INFORMATION SHEET FOR
PRELIMINARY OVERALL AREA DEVELOPMENT PLAN
(P.O.A.D.P.)

WKM 100-AC. TRACT
P.O.A.D.P. NAME

Re: W.K.M. 100 Acre Tract
(XX) Preliminary Plan
( ) P.O.A.D.P.

Re: W.K.M. 100 Ac. Tract
File #: 84-16-63-46

#132

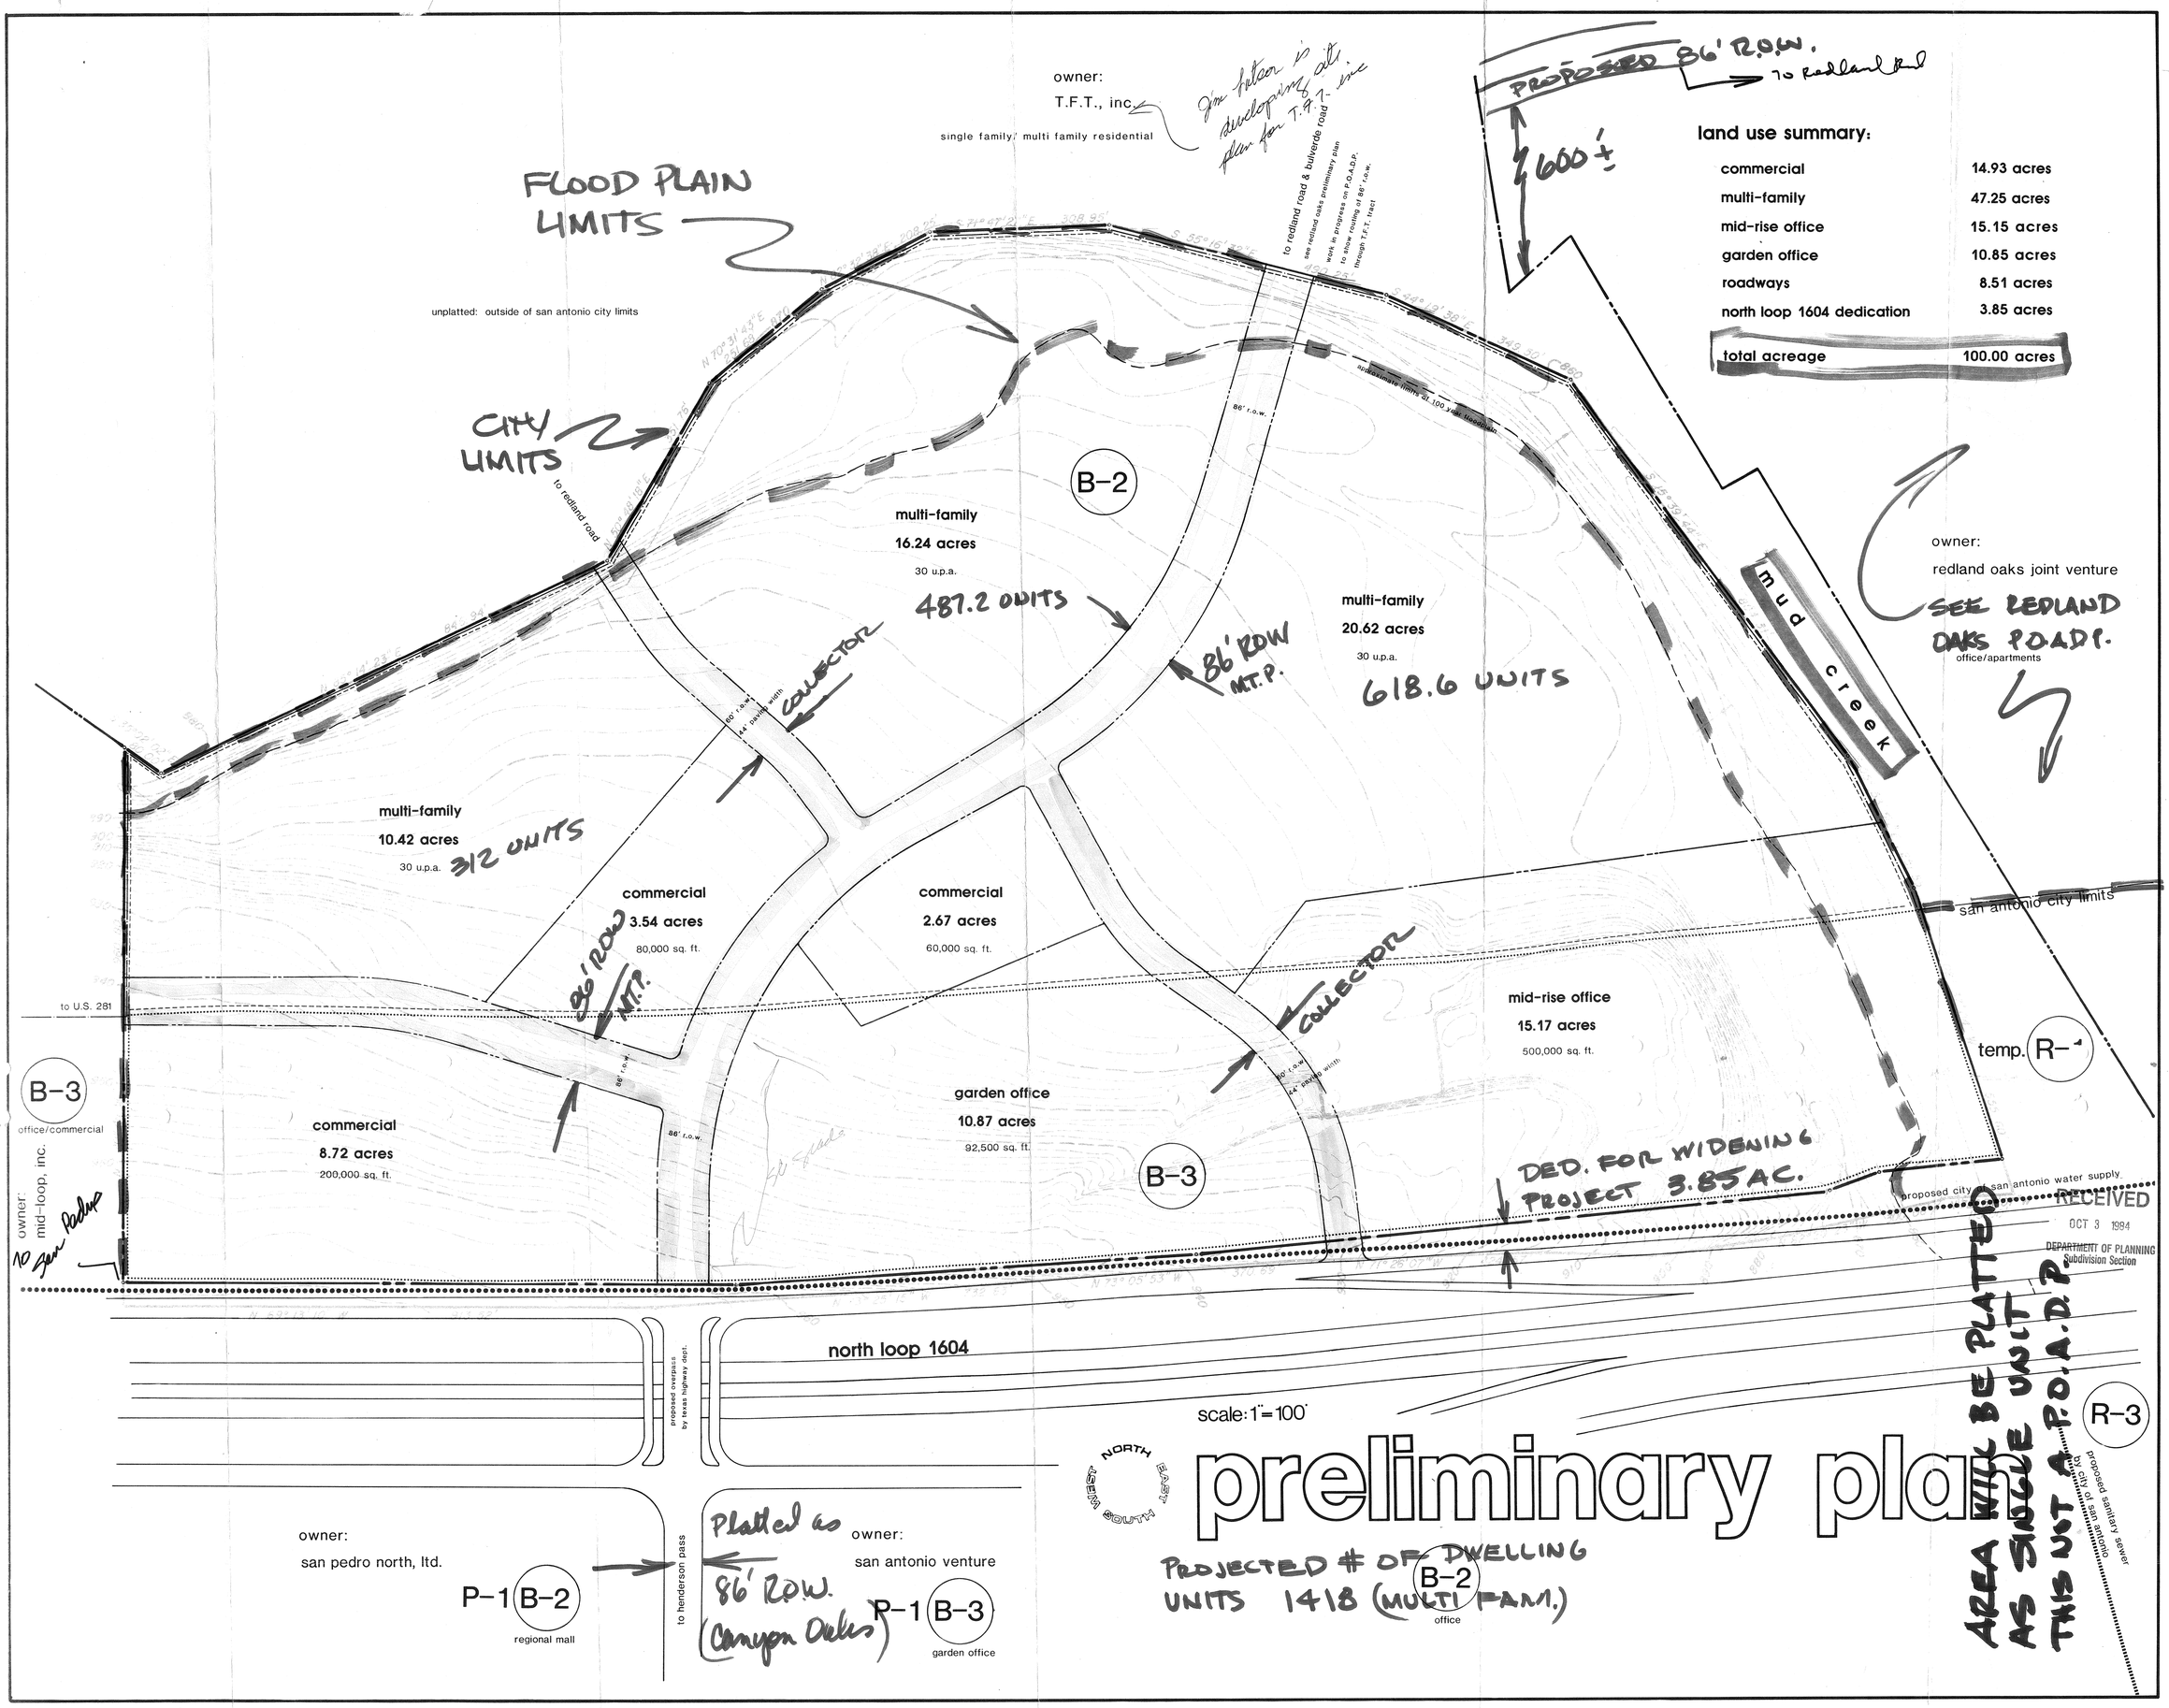
COMMENTS: Requested info that was lacking from Jim Folson 9-18-84
10-5-84
Committee reviewed plan, and there was a staff concenous to see that the collector st. jog be eliminated by directly linking the collector strut system/rational was because of current design (jog) would not facilitate expected volume of traffic between FM.1604 & Redland Rd. also as a result of the jog traffic signaling would be difficult to address. It was also suggested that entry (86' ROW) at 1604 contains excess strut grades. ← Decided to disregard last statement See addition notes on Review sheet

It is recommended that consideration be given to re-alignment of the collector street system. The new alignment being suggested is a direct linkage of the two collector streets located to the northwest and southeast of the proposed north-south 86' facility. Staff believes that a merger such as this will enhance vehicular movement in the area and also addresses a traffic signalization concern raised in the review.

10-17-84
Jim Latsen called in regards to staff recommendation
He said that the purpose of the offset street design
was to discourage through traffic. I explained
the bases for staff rec. Jim said he would discuss
the re alignment purposal with his client. & then
he would like to meet with the staff. He also
stated that the 86' facility would provide the necessary
movement between 1604 & Redland Rd.

10-23-84 Met with Jim, Pat Vi[illegible] to discuss staff comments
dated 10-10-84 Jim indicated that the plan was designed in this
fashion (offset street) to discourage thru traffic because
area to the north 108 ac. parcel is heavy planned for
res. development (5 unit per ac.)
(2) site plan has been developed and staff rec. would
require redoing of layout.
(3) anticipated traffic patterns in area do not warrant
linkage of collector streets.
(4) exit ramp design on 1604 (F.M.) would by pass
entry (collector street) at 1604.
Based on reason above requested from Jim an overall
sketch reflecting relationship of all proposed development
in the immediate area.
This will give staff a better idea of the situation

(X) Comments: Thank you for submitting to the Departments' Transportation Division the additional information reflecting the relationship of this POADP with planned development in the immediate area.

Based on the new information, the staff has reconsidered your proposal and we offer no objections.

11-2-84 Eisenmenger advised committee that the info requested by staff had been
submitted to him & based on the new info he had no problem with the design as
planned by Latsen.
